Submission for Job: #6010 SSD 6010 - One Residential Building (Student Accommodation) within Darling Drive Plot

Site: #2824 SICEEP Site, The Haymarket; Darling Drive, Sydney

SSD 6010 - One Residential Building (Student Accommodation) within Darling Drive Plot

Submission by:

LEVEL 7

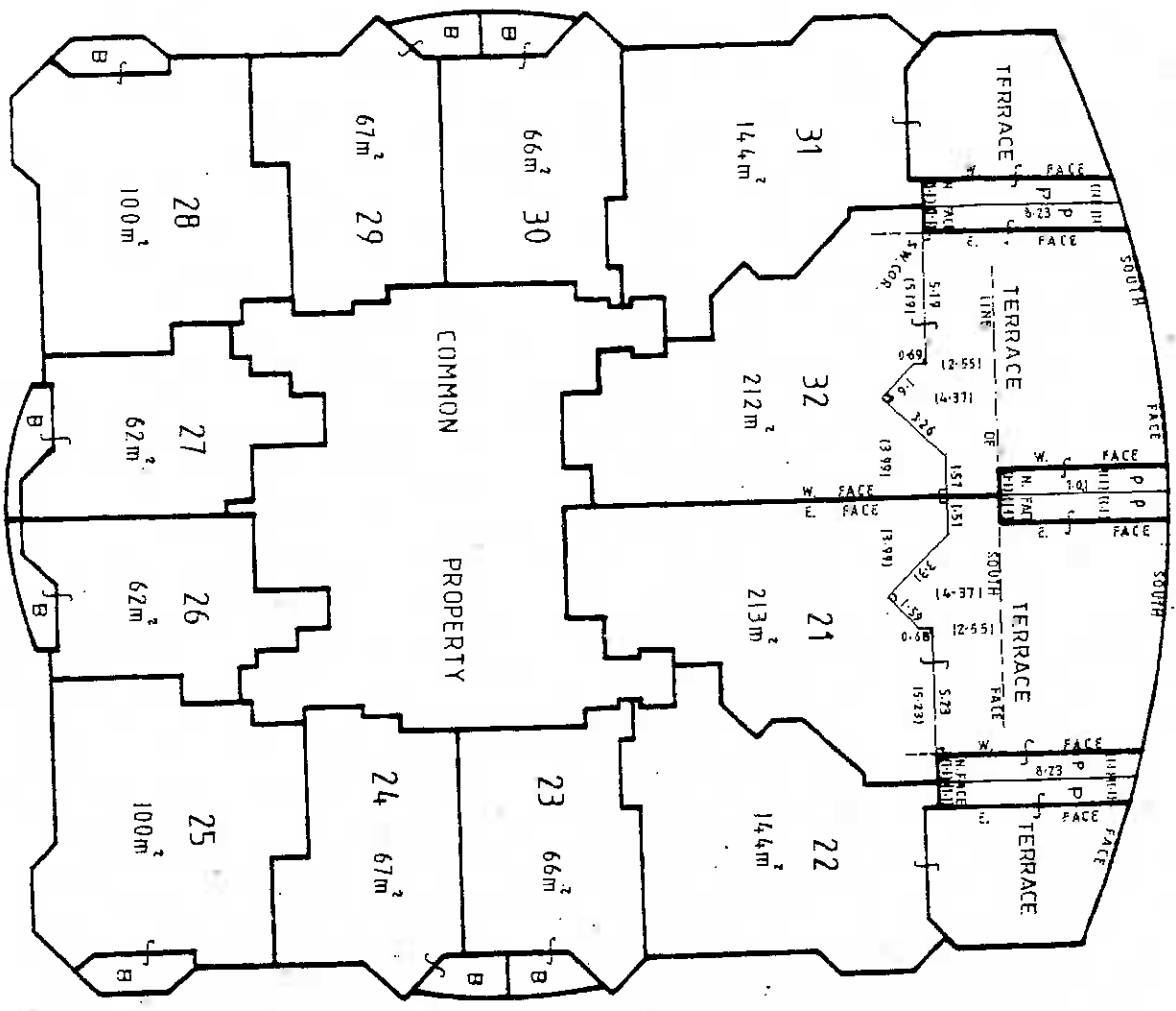
Levels 6 and 7 each contain two apartments with single west aspect , i.e. 4 single aspect apartments.

LEVEL 8

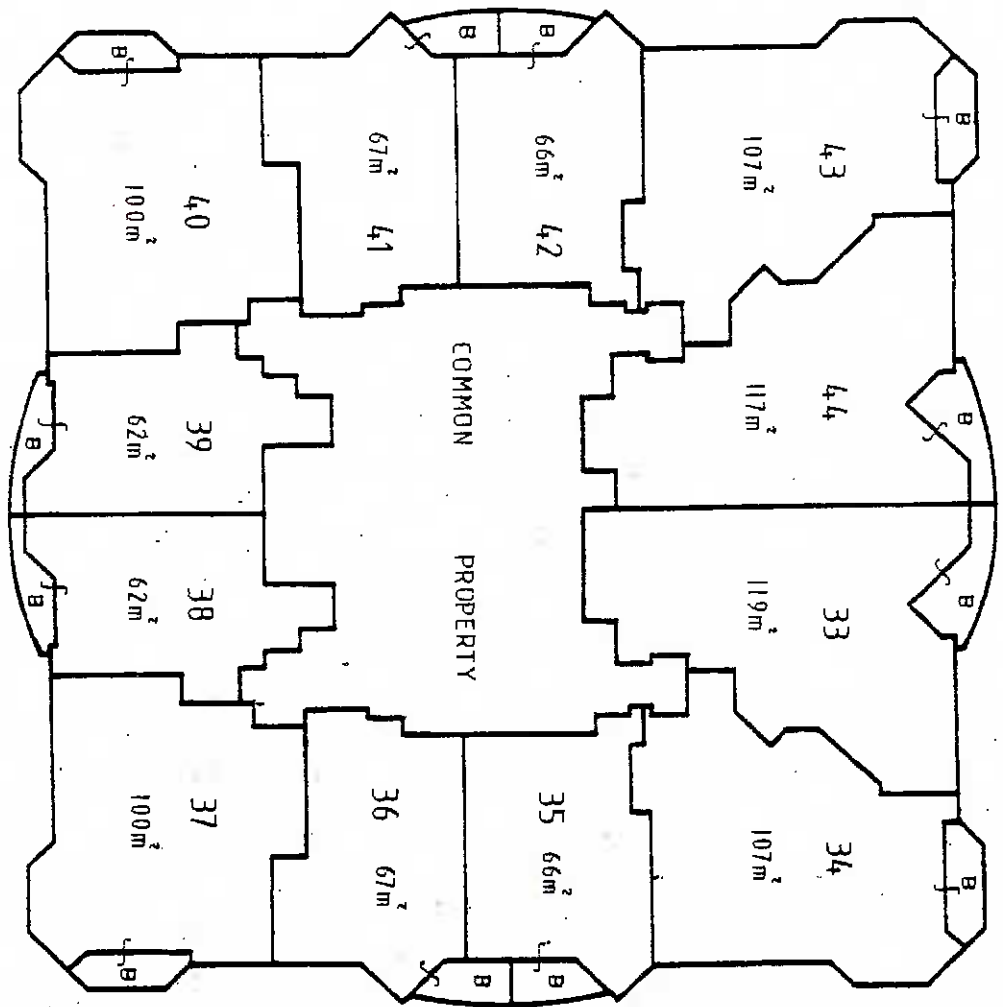
Levels 8-15 each contain two apartments with single west aspect and two apartments with single north aspect , i.e. 4 single aspect apartments per level, giving 32 single aspect apartments.
